Doug Griffin - Tuesday, 06 April 2004

1. Jamie's email
2. Relationship between total cooler load and cooler temperature
3. Extract from SPIRE-JPL-NOT-000623 - Temperature Stability Requirements for SPIRE

Comments

Figure 1 - Power and change in power corresponding to one LSB change vs. DAC value for a 12-bit DAC and 1.19uW maximum power.

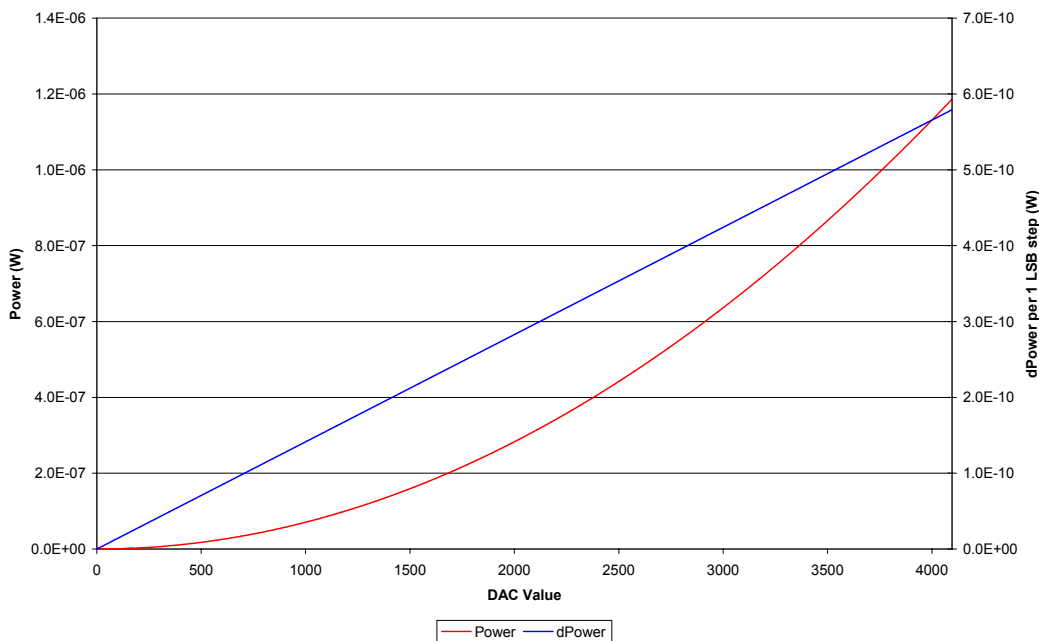
- The DAC currently implemented on the SCU is **12-bit**
- The PTC heater drive is configured as a current source and not a power source. Therefore, $V_{drive} = V_{max} \times \text{DAC value} / 2^{\text{DAC bits}}$. This means that $P_{drive} = P_{max} \times (\text{DAC value} / 2^{\text{DAC bits}})^2$. This means that the dP corresponding to one LSB is not linear. One LSB steps near the bottom of the ACD range produce a very small increment in power, while one LSB steps at the top of the ACD range yield a proportionately coarse step.

- Table 1 gives the corresponding cold tip dissipation and temperature rise for various numbers of bits over and above 12-bits with 1.19uW maximum.

Figure 2 - Schematic for achieving greater than 12-bit precision on PTC heater commanding.

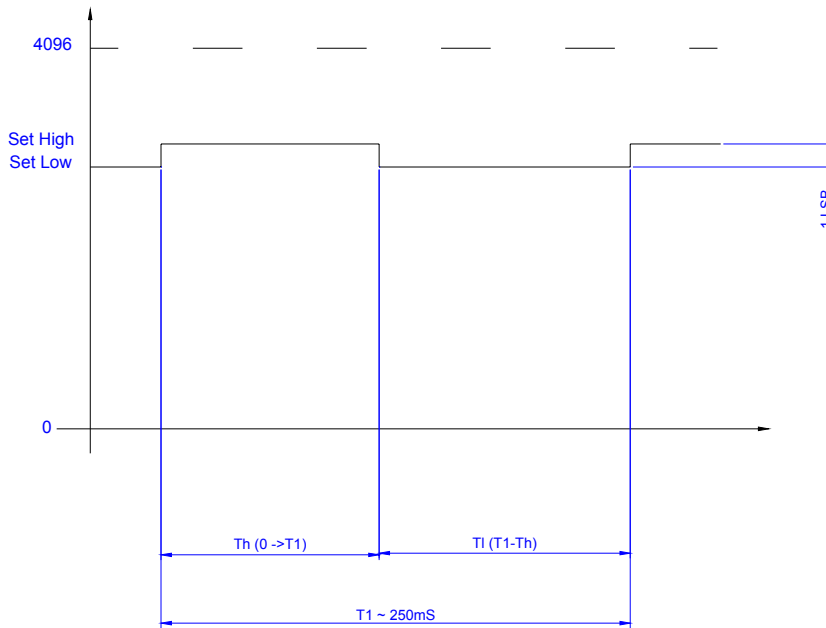
- According to Jamie's email, the control precision is insufficient with a 12-bit ADC.
- There are two possible means by which the extra precision on the heat dissipated in the PTC can be achieved. They both involve using a duty cycle on the DAC setting for the PTC heater drive as indicated in Figure 2. This could be carried out in one of two ways;

- Use the DPU to send commands to the DPU to switch between two ADC values. This would use the LSL and one of the Virtual Machines.
 - Use the FPGA in the SCU to switch between the two DAC settings.

- The DPU is capable of sending commands to the SCU using the Virtual Machine on the Low Speed Link with an estimated jitter of 0-5mS at a maximum frequency of around 10 commands/per second. The jitter on the implementation of the command would limit the number of extra bits of precision that could be achieved. The commanding speed would limit the temperature ripple induced by switching between the two DAC states.

- If a cycle is taken to be 250mS long, then 5mS jitter represents about 5 or 6 extra bits of precision.

- If the FPGA was used, then presumably even more precision could be achieved (in terms of less jitter and faster switching and consequently less temperature ripple). The cost of this is the time and difficulty of re-programming the FPGA. Availability of system resources on the FPGA is also an unknown.
- If we are to embark on a procedure whereby the ADC is switched between two values to achieve extra precision on the PTC heater commanding, then I would opt for DPU commanding.

Figure 3 - To achieve a 48 hour hold time, the total load needs to be around 30uW (depending on the L0 temperature during recycle).

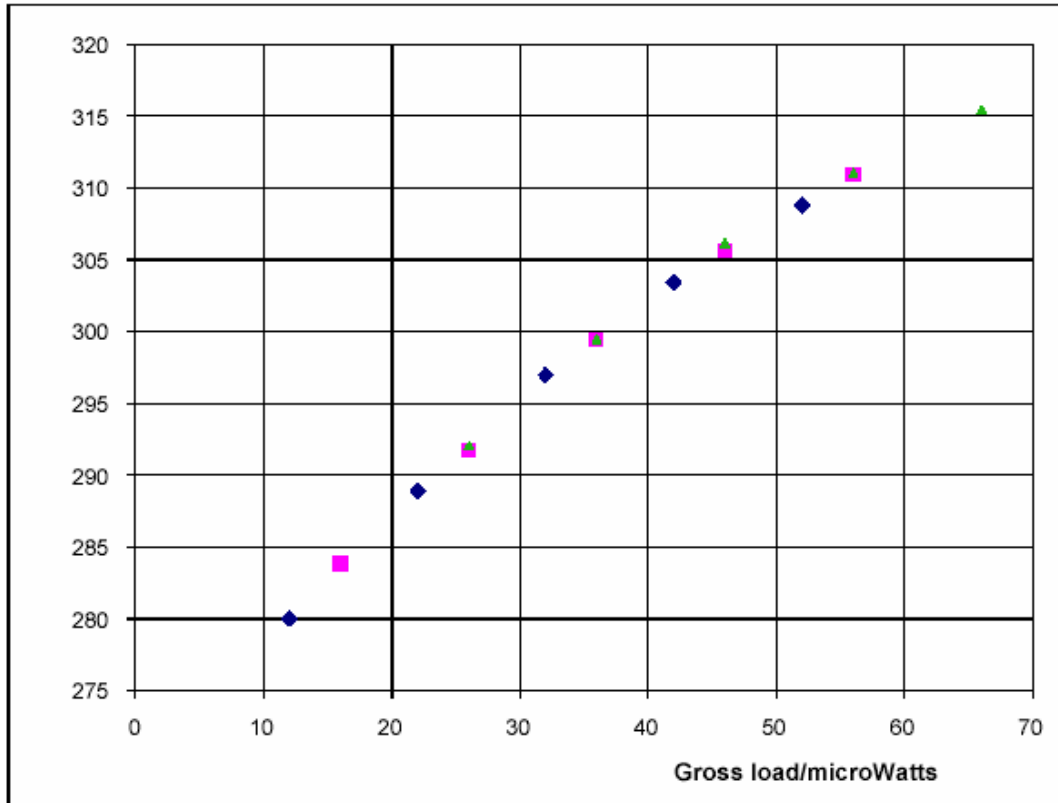
- The total (internal parasitics + useful coolth) cooler load cannot be more than **approximately**¹ 30uW to achieve a hold time of 48 hours. A maximum of 10uW seems very high.

- From attachment Two, it can be seen that the first order linearised function of cold tip temperature vs. total cooler load at the operating point is **0.63mK/uW**
